ADDENDUM NO. 1
May 20th, 2025
WESTSIDE DRIVE DRAINAGE, WATER AND ROADWAY IMPROVEMENTS
EXETER, NEW HAMPSHIRE

The following changes and information are hereby incorporated into the Contract Documents (Project Manual and Drawings).

BIDDER REQUEST FOR INFORMATION & ENGINEER RESPONSES

ENHANCED BIO-FILTRATION UNIT
W/ INTERNAL STORAGE RESERVOIR
NOT TO SCALE

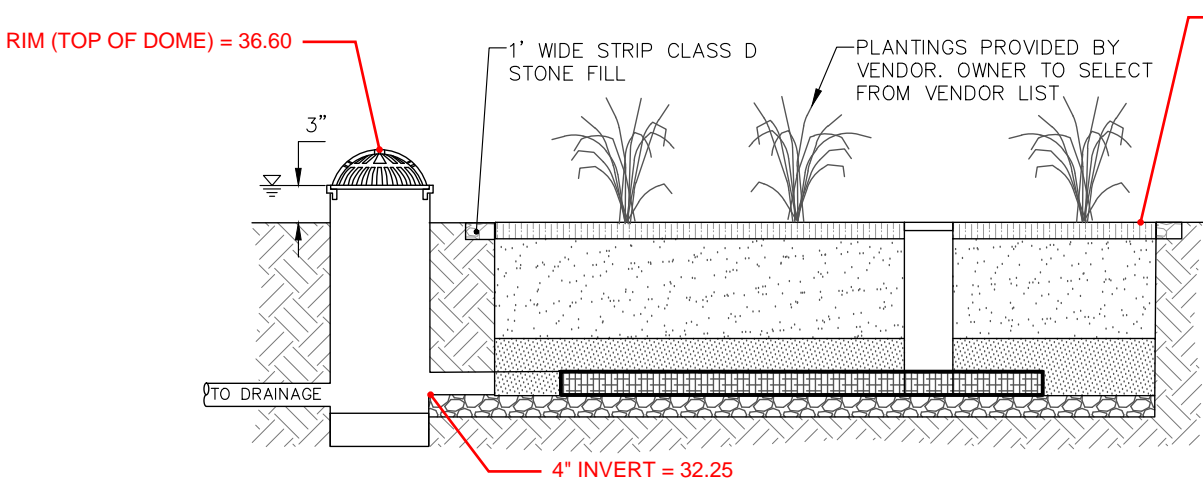
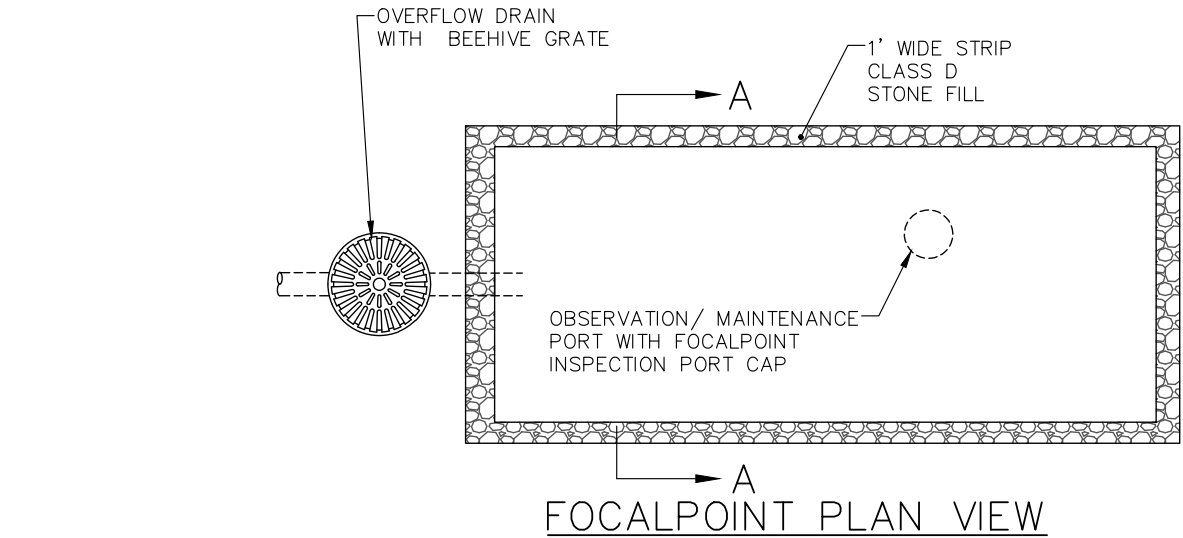
RFI #3: Could you provide the top of mulch elevation and outlet pipe elevation for the Focal Point Enhanced Bio-Filtration Unit?

Engineer’s Response: See Attachment “C” in Addendum No.1 for additional elevation information.

- 1. TREATMENT CHAMBER SIZES SHOWN IN PLAN VIEW ARE APPROXIMATE AND VARY BY MANUFACTURER (SEE SCHEDULE).
- 2. HIGH RATE BIOFILTRATION SHALL BE FOCALPOINT OR APPROVED EQUAL (SEE SECTION 02607 OF THE PROJECT MANUAL).
- 3. DIMENSIONS AND DEPTH OF SOIL CROSS SECTION VARY BY MANUFACTURER. ADJUST SLOPE OF OUTLET PIPE AS NECESSARY TO PROVIDE UNIFORM SLOPE DRAINING TO THE INVERT ELEVATION SPECIFIED AT THE DOWNSTREAM DRAINAGE STRUCTURE.
- 4. SEE DRAIN MANHOLE DETAIL FOR BEDDING AND BACKFILL REQUIREMENTS.
- 5. PLANT QUANTITIES ARE FURTHER DETAILED IN SECTION 02607 OF THE PROJECT MANUAL (SEE FILTERRA BIOSCAPE VAULT PLANT PALETTE AND FOCAL POINT PLANT SELECTION GUIDE).
